CHANGE ORDER

CHANGE ORDER NUMBER
3
4/18/2022
Page 1 of 10

<input checked="" type="checkbox"/> ORDERED BY ENGINEER UNDER SECTION 1-04.4 OF THE STANDARD SPECIFICATIONS. <input type="checkbox"/> CHANGE PROPOSED BY CONTRACTOR.	PROJECT IDENTIFICATION PROJECT NAME: North Creek Trail Phase 1 – SR524 to Sprague Drive PROJECT NUMBER: RC1776, RR6318, RR6323, RR6319, RC1798
CONTRACTOR ENDORSEMENT: <div style="display: flex; justify-content: space-between;"> SIGNATURE DATE </div> <hr/> <div style="display: flex; justify-content: space-between;"> PRINT NAME TITLE </div>	CONTRACTOR: Rodarte Construction, Inc. ADDRESS: 17 East Valley Hwy E Auburn, WA. 98092

This Change Order compensates the Contractor for added work required to grind and pave a full-width HMA overlay on Filbert Drive and Winesap Road adjacent to the North Creek Trail Phase 1 Project.

REFERENCE SHEET NO. CH04
SHEET 127 OF 171 SHEETS

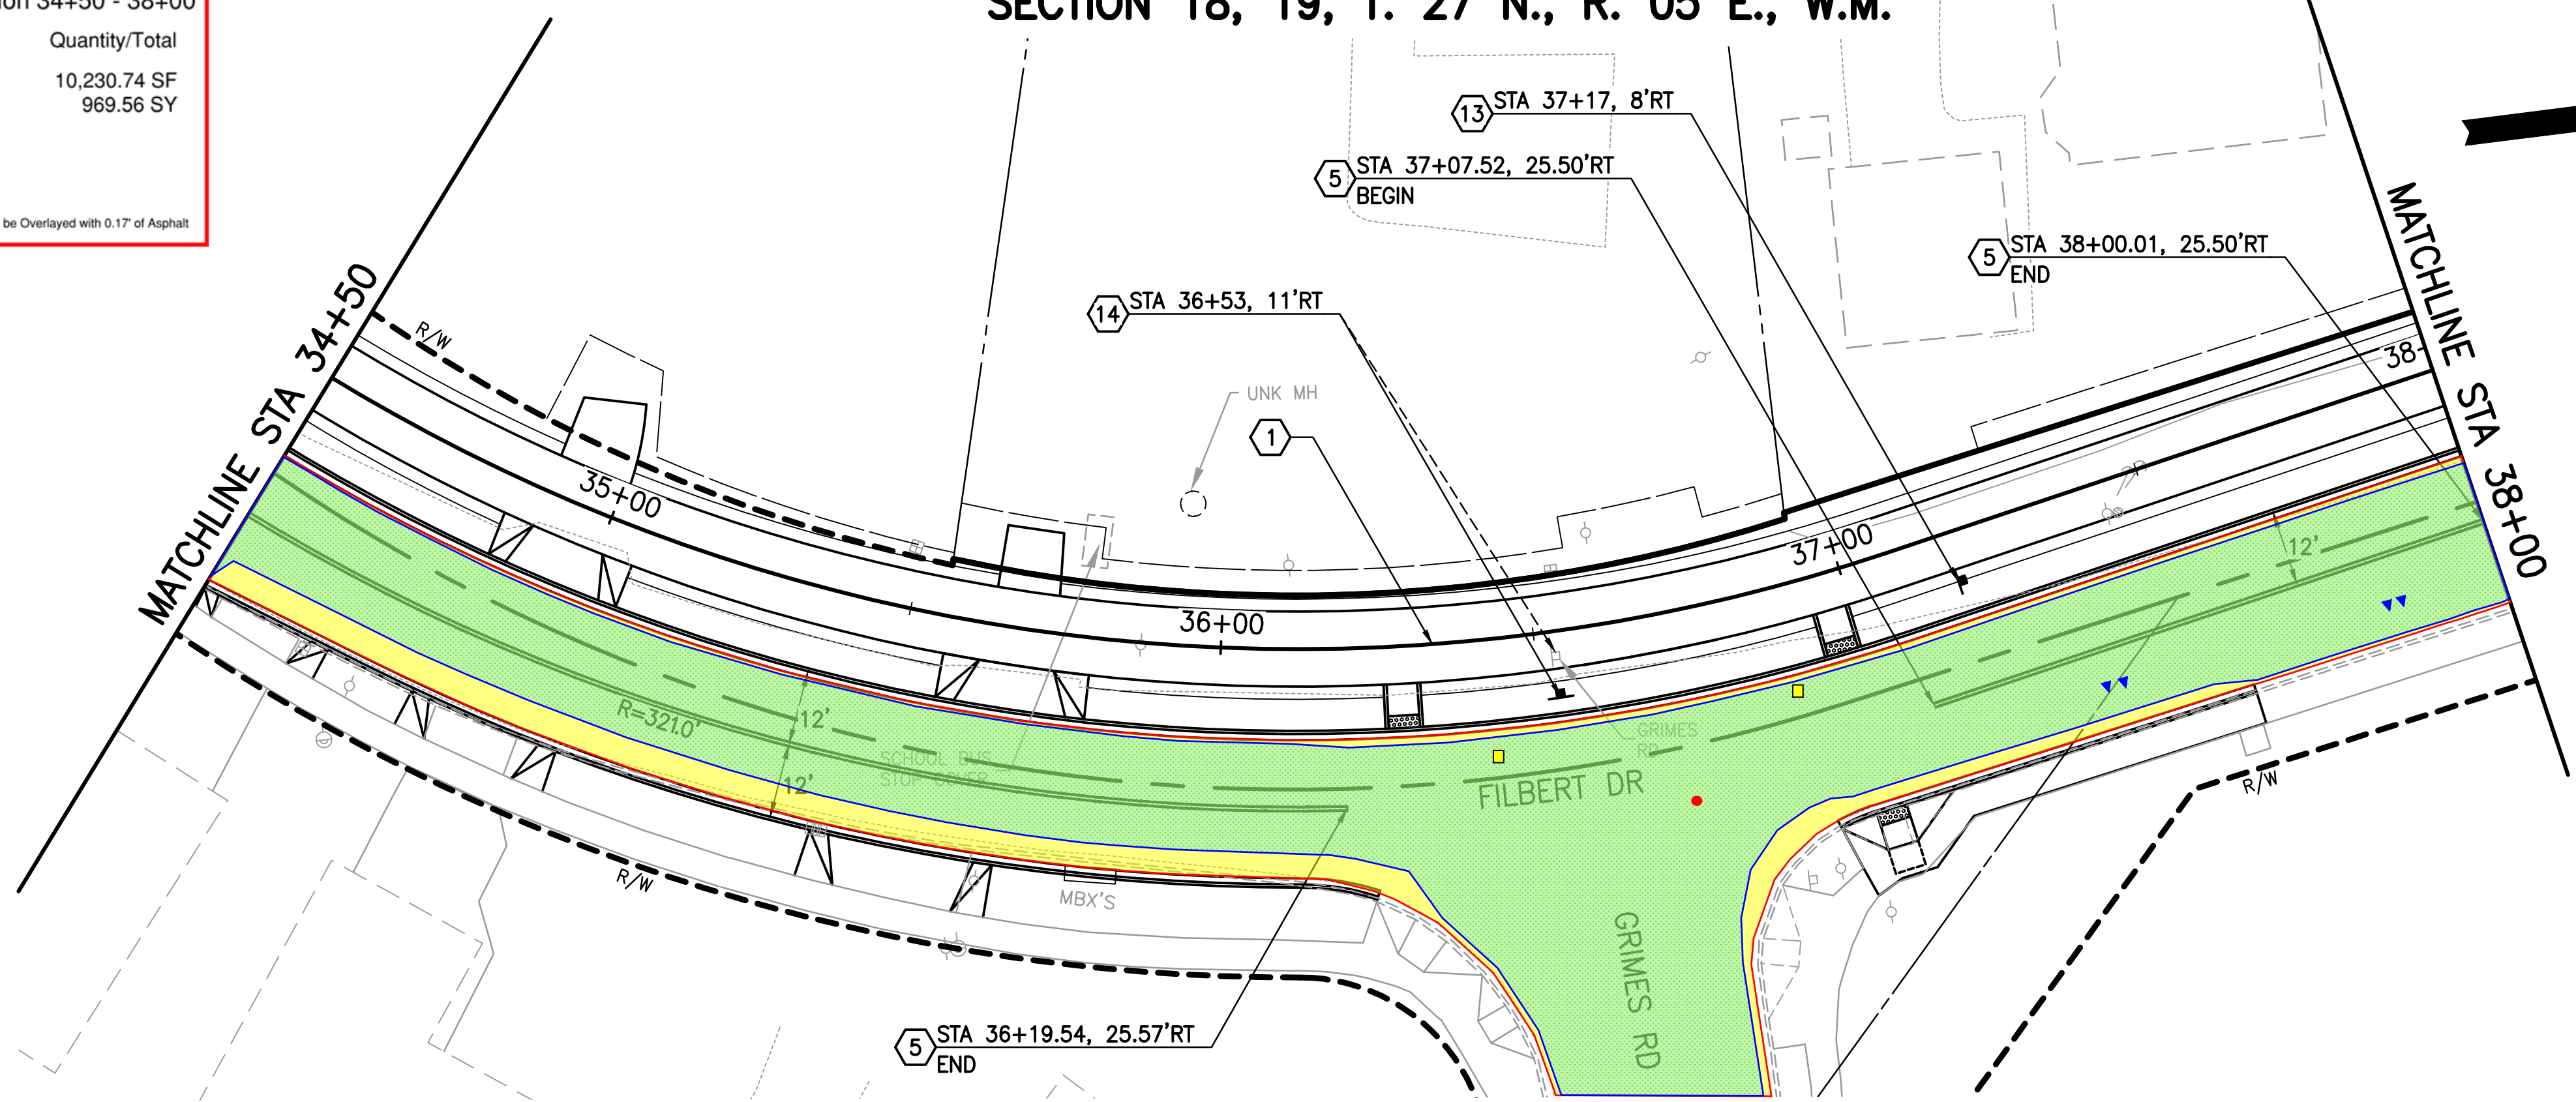
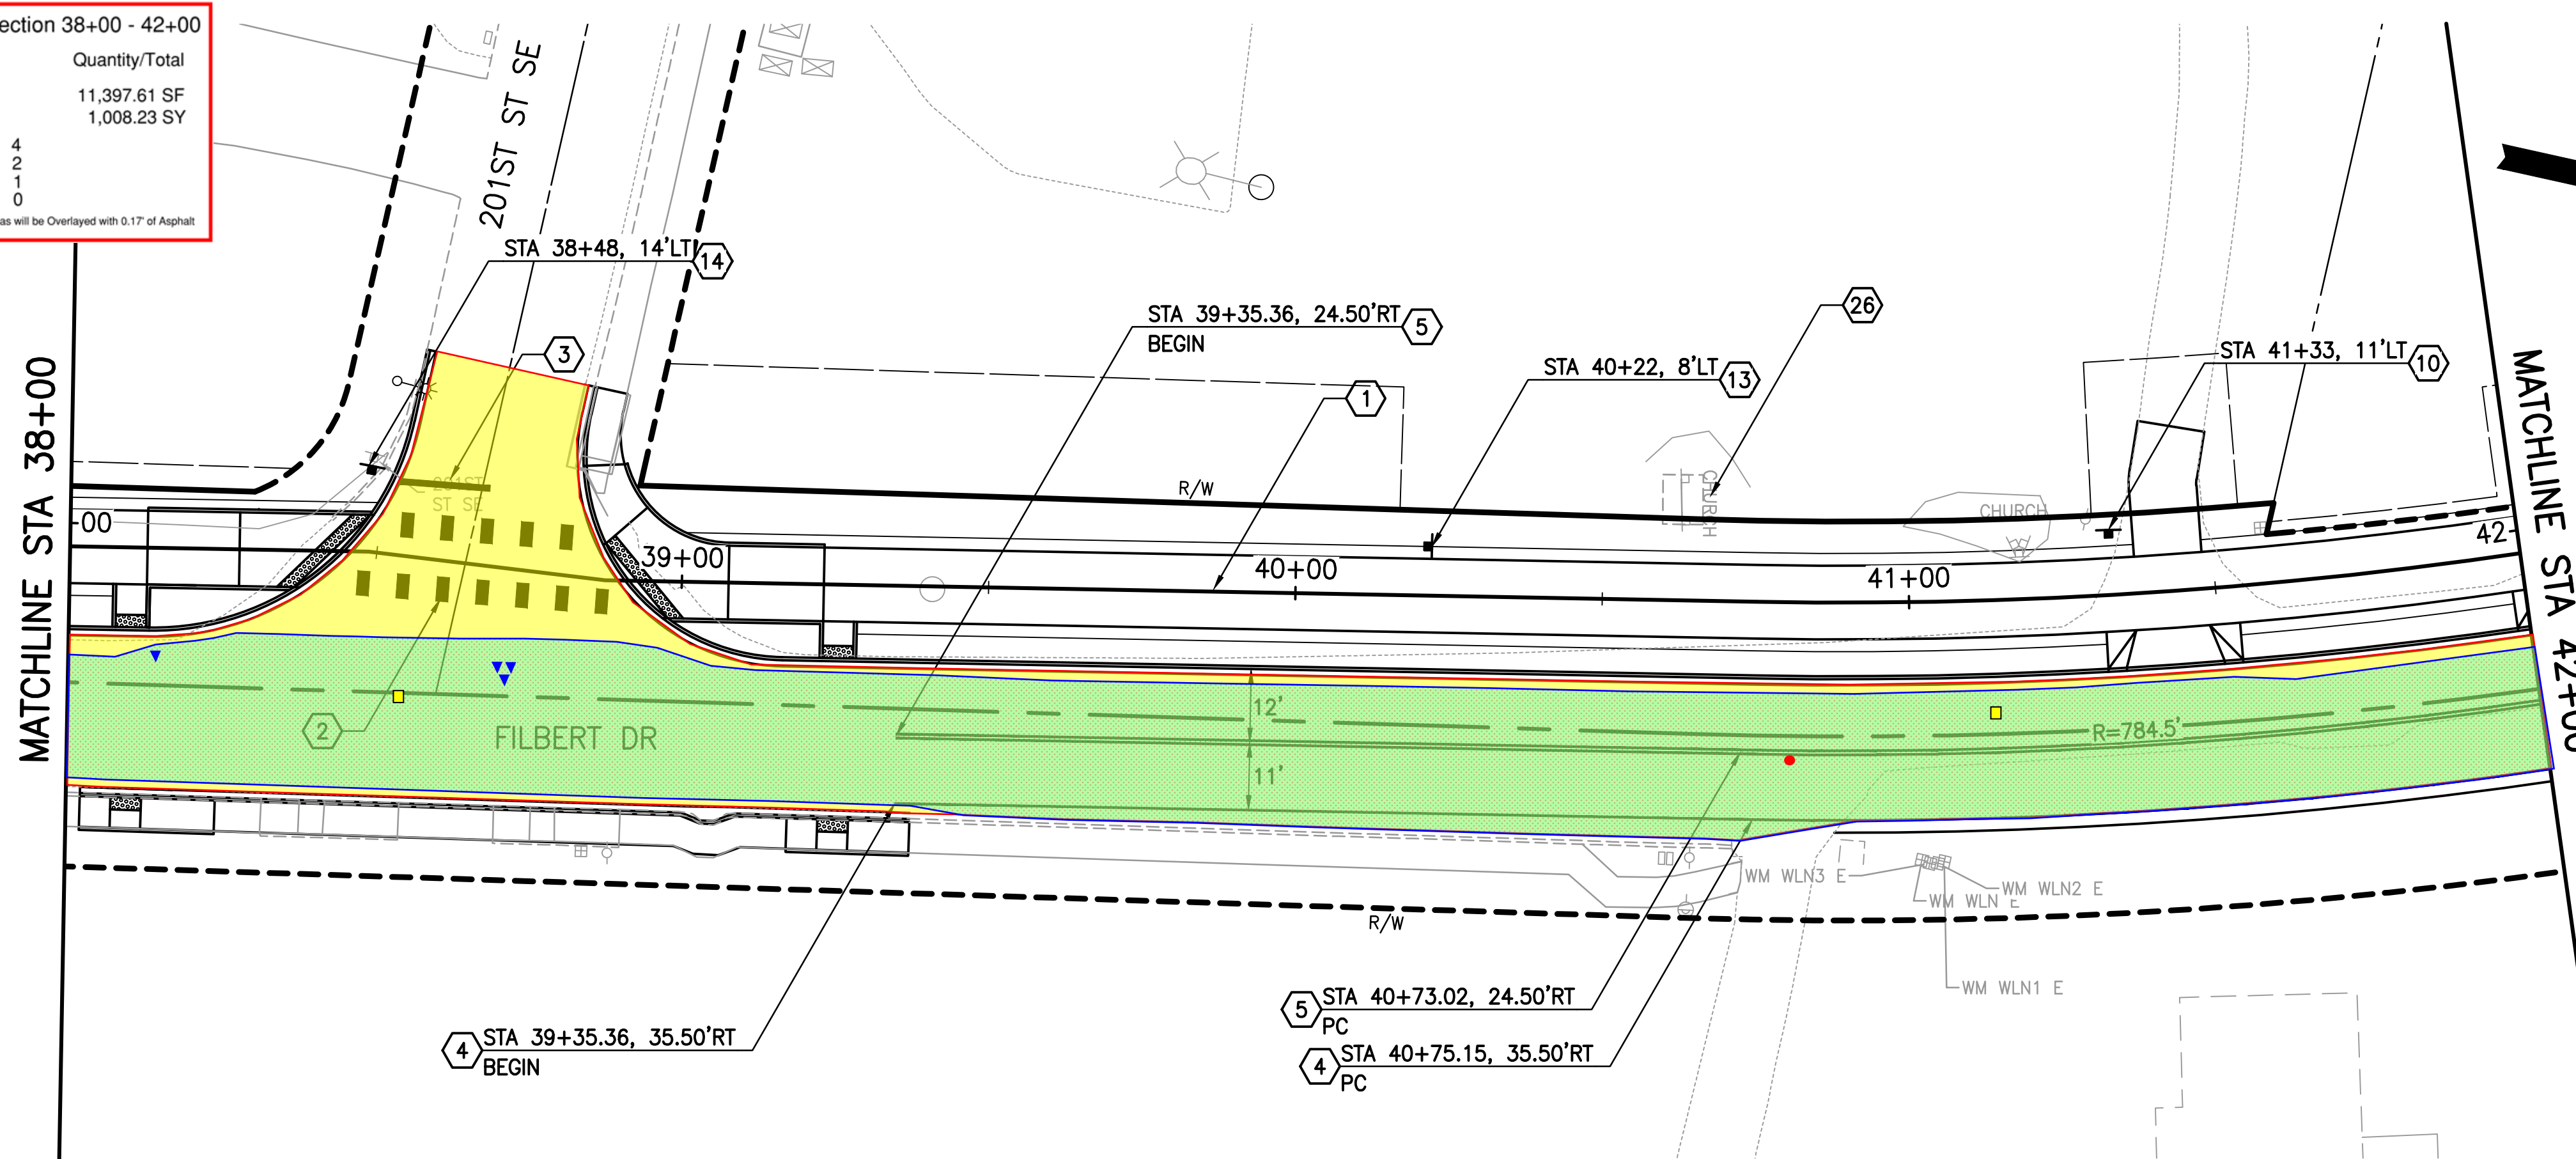
Legend This Section 34+50 - 38+00

Description	Quantity/Total
Paving Area	10,230.74 SF
Planing Area	969.56 SY
Water Valve	4
Sewer	2
Monument	1
Catch Basin	0

* Both Green and Yellow Areas will be Overlaid with 0.17" of Asphalt

Legend This Section 38+00 - 42+00

Description	Quantity/Total
Paving Area	11,397.61 SF
Planing Area	1,008.23 SY
Water Valve	4
Sewer	2
Monument	1
Catch Basin	0

* Both Green and Yellow Areas will be Overlaid with 0.17" of Asphalt

REFERENCE SHEET NO.
CH07
SHEET 130 OF 171 SHEETS

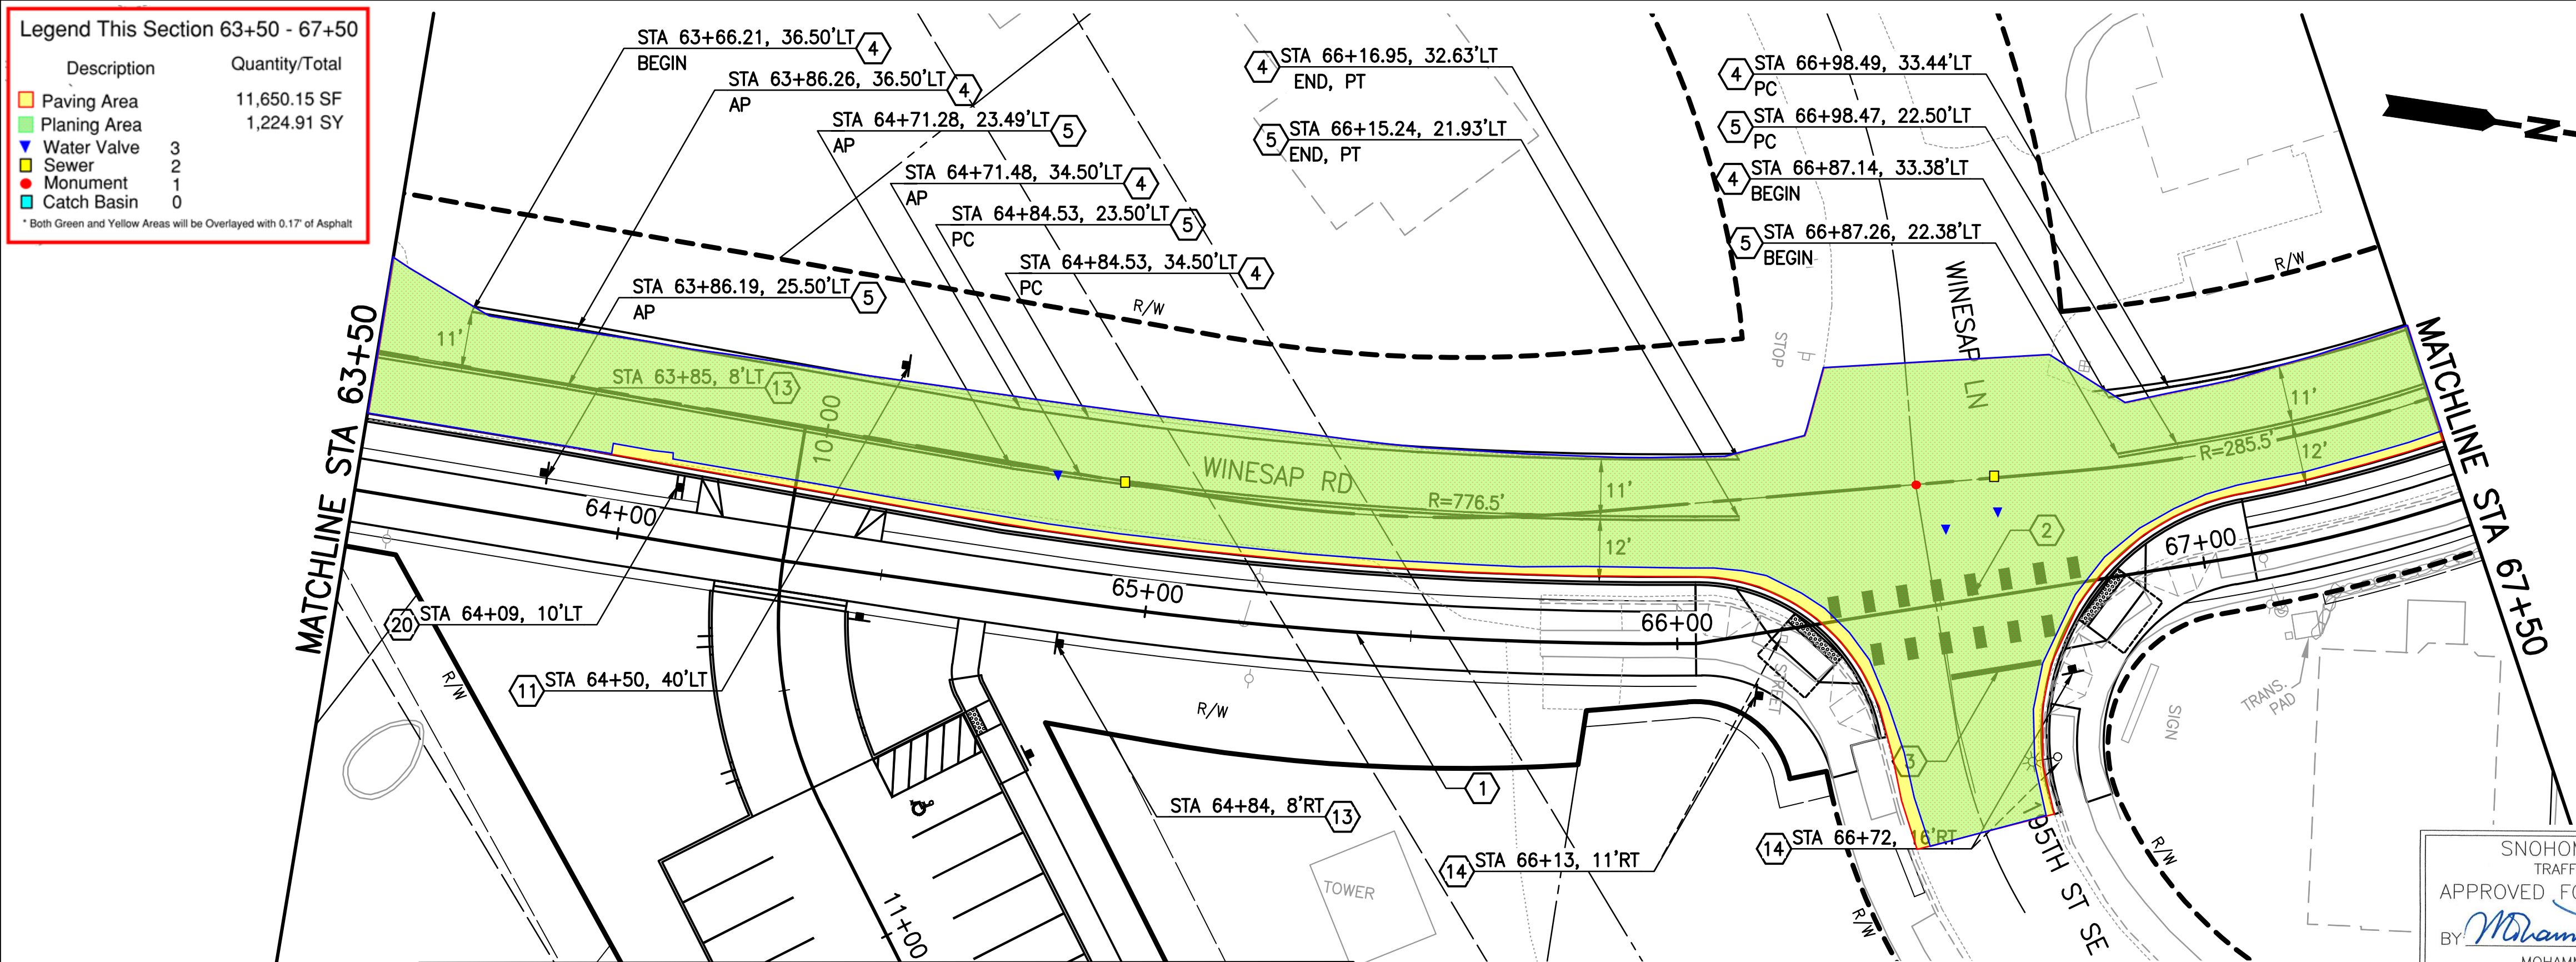
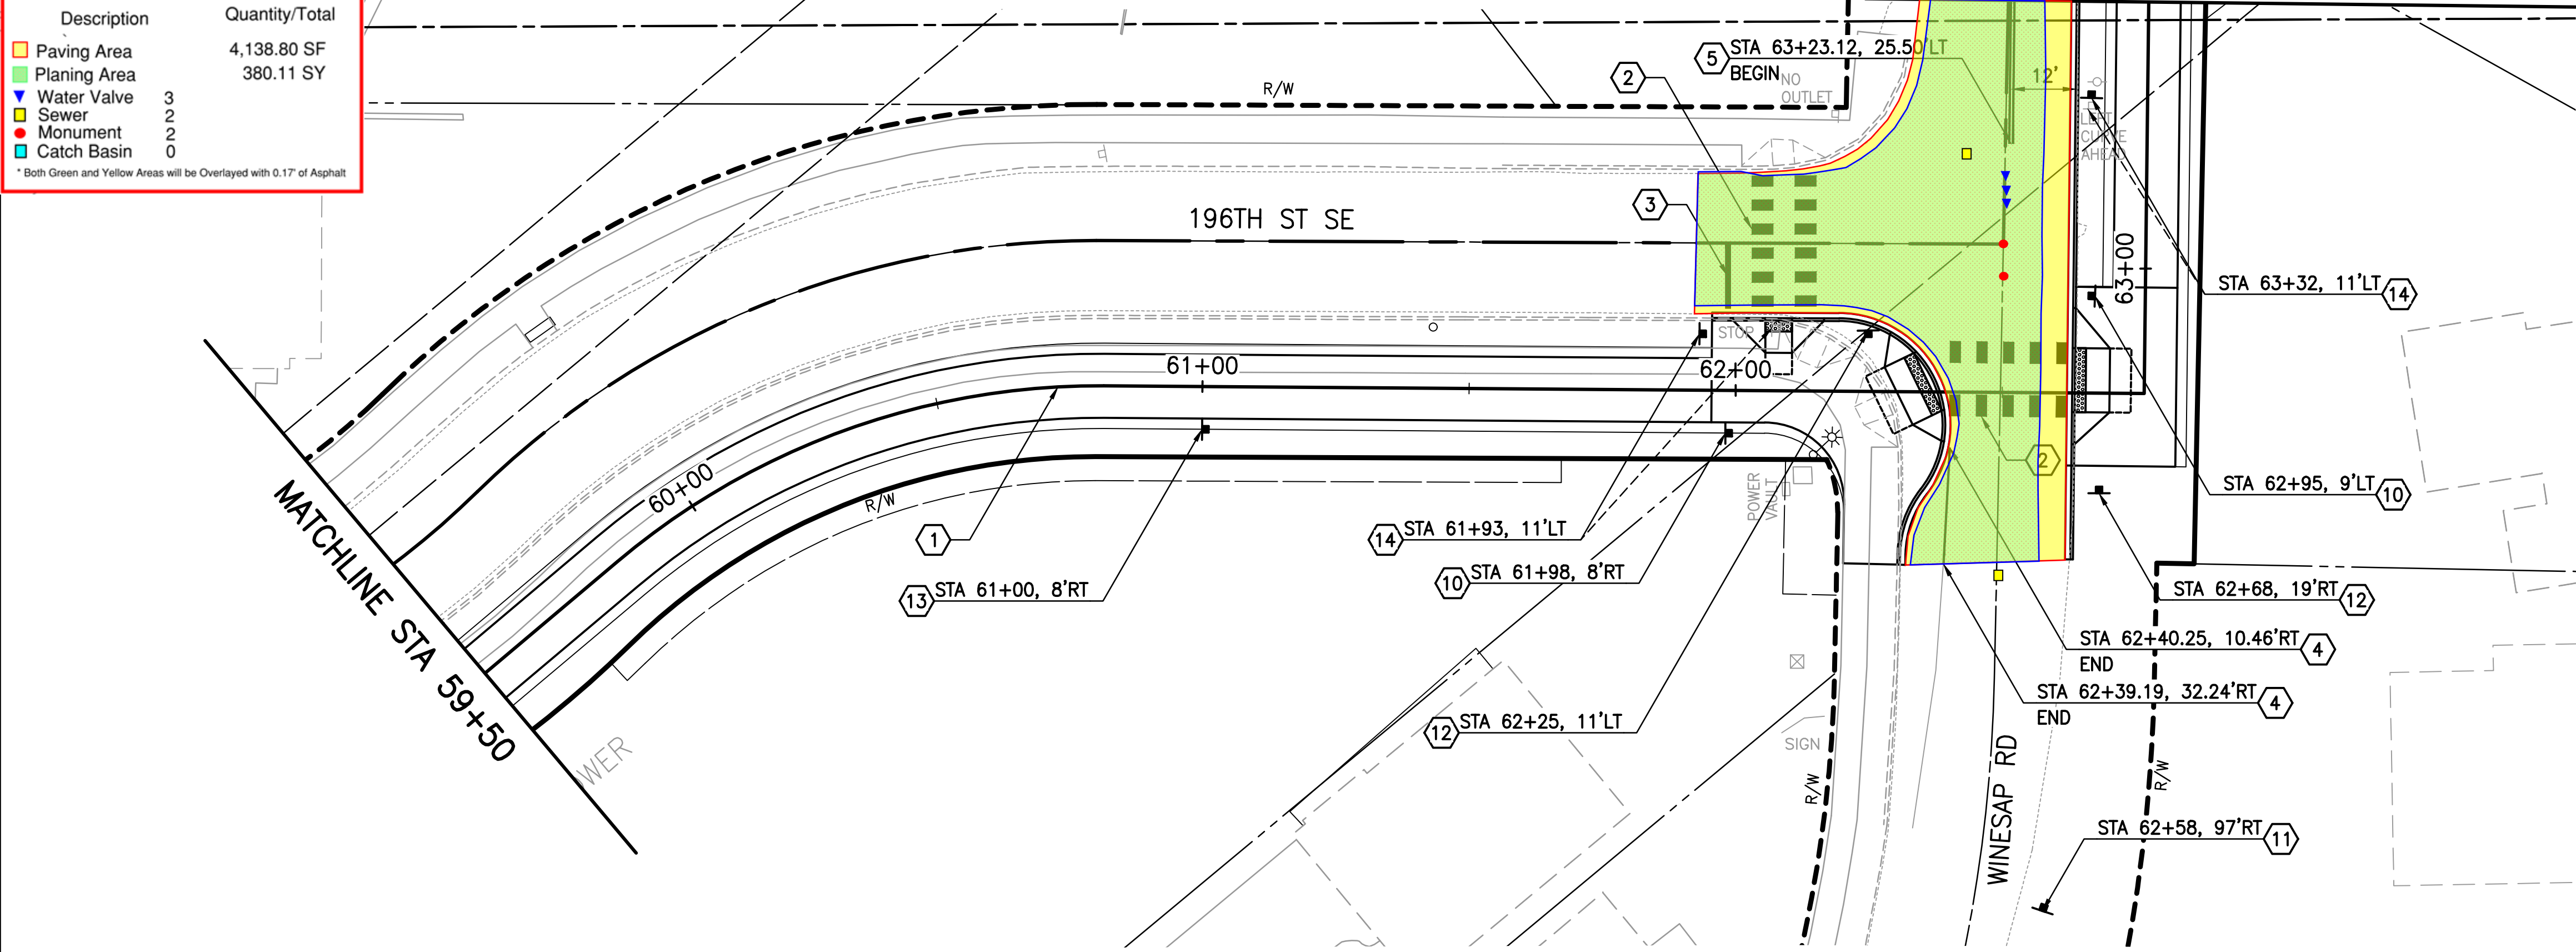
Legend This Section 59+50 - 63+50

Description	Quantity/Total
Paving Area	4,138.80 SF
Planing Area	380.11 SY
Water Valve	3
Sewer	2
Monument	1
Catch Basin	0

* Both Green and Yellow Areas will be Overlaid with 0.17" of Asphalt

Legend This Section 63+50 - 67+50

Description	Quantity/Total
Paving Area	11,650.15 SF
Planing Area	1,224.91 SY
Water Valve	3
Sewer	2
Monument	1
Catch Basin	0

* Both Green and Yellow Areas will be Overlaid with 0.17" of Asphalt
